SUBJECT: PC 23-15: 530 E. North Avenue (Shahi Banquets)

INTER-DEPARTMENTAL REVIEW COMMITTEE REPORT

SHAHI BANQUETS – 530 E. NORTH AVE.

PC 23-15

Figure 1 AREA OF ZONING RELIEF

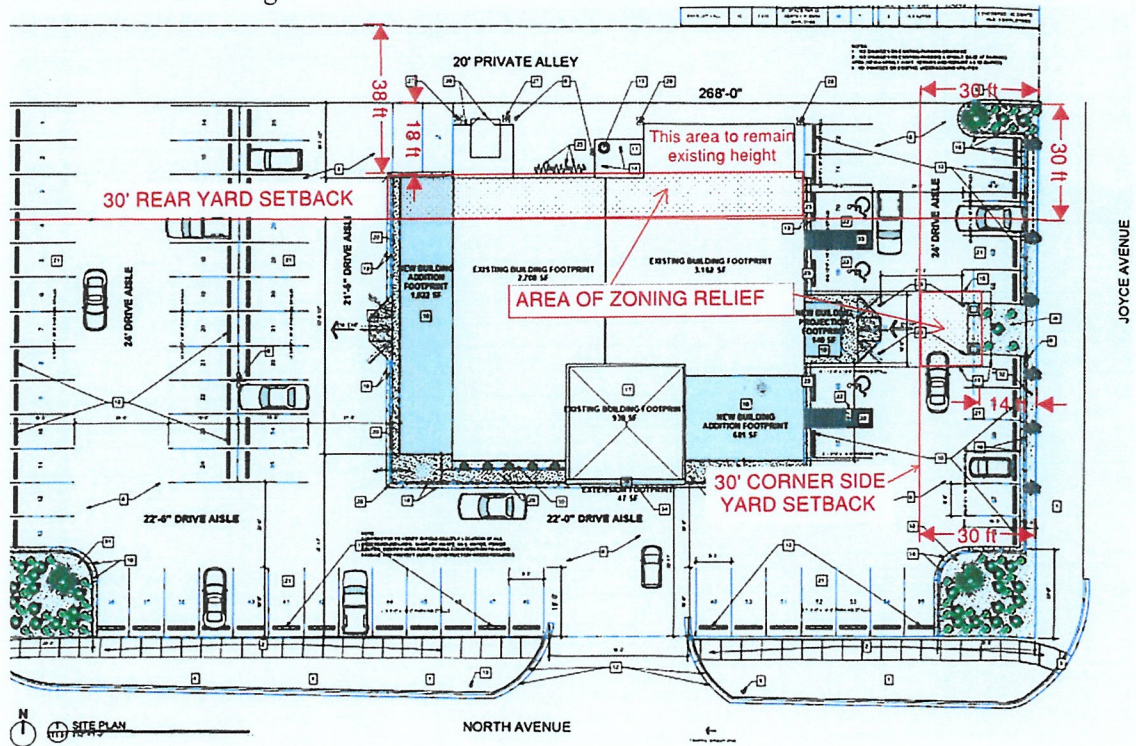
1. Pursuant to Section 155.416(F)(2) approve a variation for a corner side yard setback of 14’ where 30’ is required.

The petitioner proposes to construct a porte-cochere entrance (permanent canopy structure) over the east drive aisle for guests to exit vehicles covered from the weather. See Figure 1 below.

Staff supports this request since the proposed removal of two parking spaces required for the supports of the structure does not fall below the required per the zoning code of 72 parking spaces and provides the opportunity for additional landscaping island for the parking lot. Furthermore, the proposed porte-cochere would be seen from Joyce Avenue to the east and a residence to the north located at 2N048 Joyce Avenue that is approximately 70’ from the proposed porte-cochere entrance. This house is approximately 43’ from an existing addition to the existing building constructed in 1974 (permit #22858 for a storeroom, no plans were found with the permit). This existing addition is approximately 5’ from the subject’s rear property line and 25’ from the 2N048 Joyce Avenue property line.

2. Pursuant to Section 155.416(F)(4) approve a variation for a rear yard setback of 18' where 30' is required.

The petitioner proposes to construct an addition on the west side of the existing building for additional storage and an office. No further additional banquet seating is proposed in this addition. See Figure 1. This addition and increasing the height of the building overall requires the variance.

Figure 2 - SITE PLAN FROM PERMIT 20500 (from 1972)

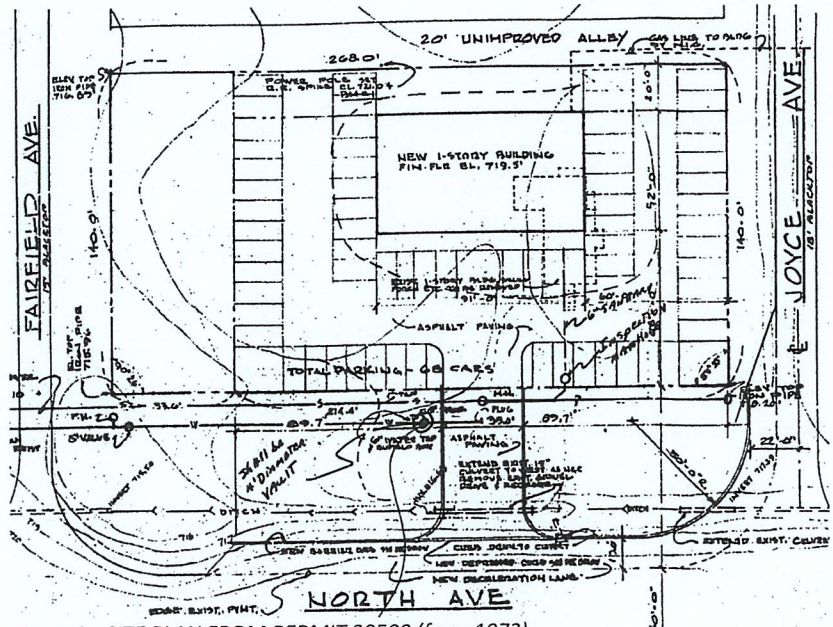
The property is restricted to the north by an existing alley. However, the alley serves the subject property exclusively as incorporated into the parking lot as a drive aisle. Therefore, a variance to the rear yard setback is needed for the proposed building addition on the west side holding the rear line on that side of the existing building. The alley not being part of the property but functioning as an integrated part of the parking lot circulation, is creating the hardship. If the alley were consolidated with the subject property, the building would be 38' from the property line, and relief would not be required. However, the existing building is setback at eighteen feet (18') and the addition will match and align with the existing western half of the building line.

Staff supports the request noting that it appears that the property was intentionally developed with the existing alley providing direct access to the parking lot as evidenced by the approved plans for permit #20500 (see Figure 2). The proposed addition will require the removal of seven of the 82 existing parking spaces but will not fall below the required per the zoning code of 72 parking spaces. The variance request would not alter the neighborhood character since whether the alley is privately owned or not, does not change its appearance.
